**Re: Appeal of Tentative Final Map No. 8593 for the proposed Golden State Warriors Event Center and Mixed-Use Development Project at Mission Bay South Blocks 29-32, Assessor's Block No. 8722, Lot Nos. 1 and 8 (Clerk of the Board File No. 151204)**

**DIRECTOR'S CONDITIONAL APPROVAL OF TENTATIVE FINAL MAP NO. 8593**

San Francisco Public Works hereby approved Tentative Final Map No. 8593, Assessor's Block 8722, Lots 1 and 8, prepared for and on behalf of GSW Arena, LLC ("GSW") by Martin Ron and Associates. ("Tentative Final Map") subject to compliance with the following findings and conditions:

**PROPOSED TOPOGRAPHY, PARCELS AND EASEMENTS**

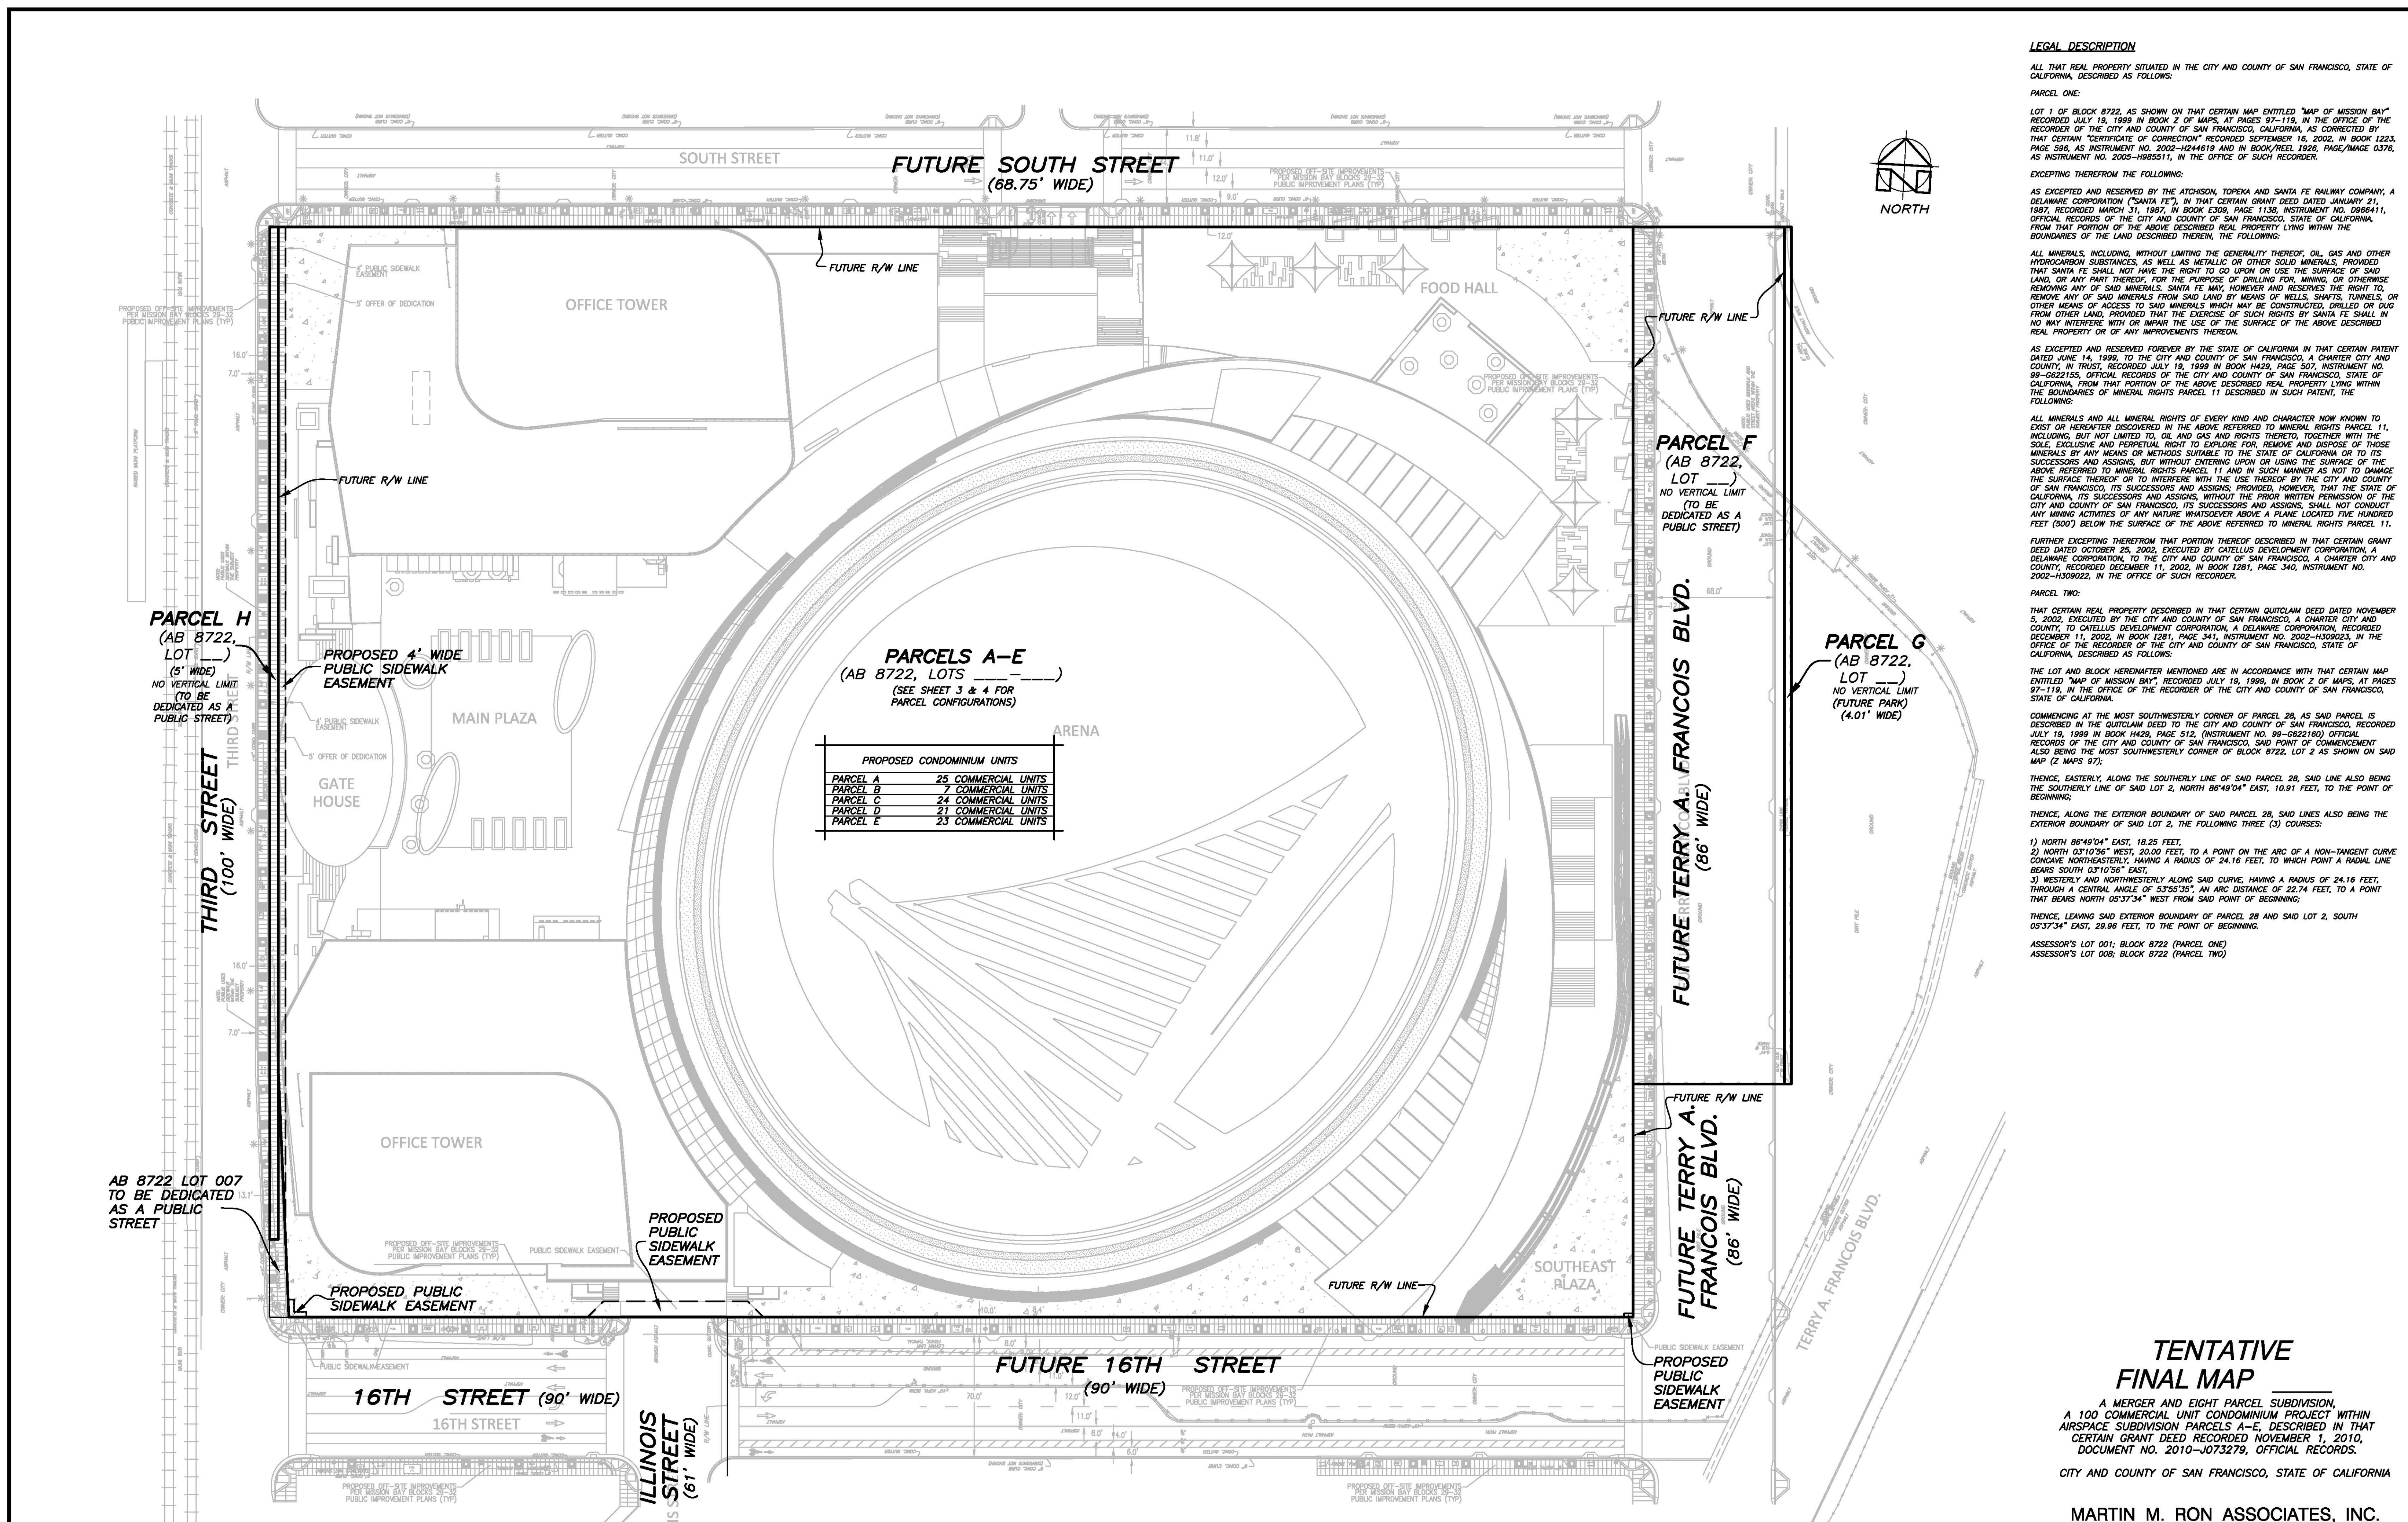
6. The Subdivider shall resolve, to CDD's satisfaction, the following issues found in this map that must be addressed on the Improvement Plans:
  - a. The 12" AWSS water main on 3rd Street is not shown as being continuous.

line. At the intersection of 16th and Illinois Streets, a gate valve and air valve on the main are 12' south of the northern property line. Verify the location of this main in the field and provide accurate information in all future submittals.

- d. Specify the utilities of the 18" steel main and the 2" pipe on 16<sup>th</sup> Street.
  - e. Locations of water mains do not match our records. Verify the locations of water mains and clearly specify on future drawings whether the mains and services are existing or proposed.

- f. Clearly call out the proposed connections between existing water mains and the proposed mains or services.
  - g. What does the proposed potable water line connect to at Illinois Street? The drawing shows it connecting to nothing. All proposed connection points should be clearly identified.

- h. The size of the new LPW on 16th Street should be clearly depicted on improvement plans.
7. Water meters of laterals of 2" lines or larger must be a minimum of five feet from proposed trees.
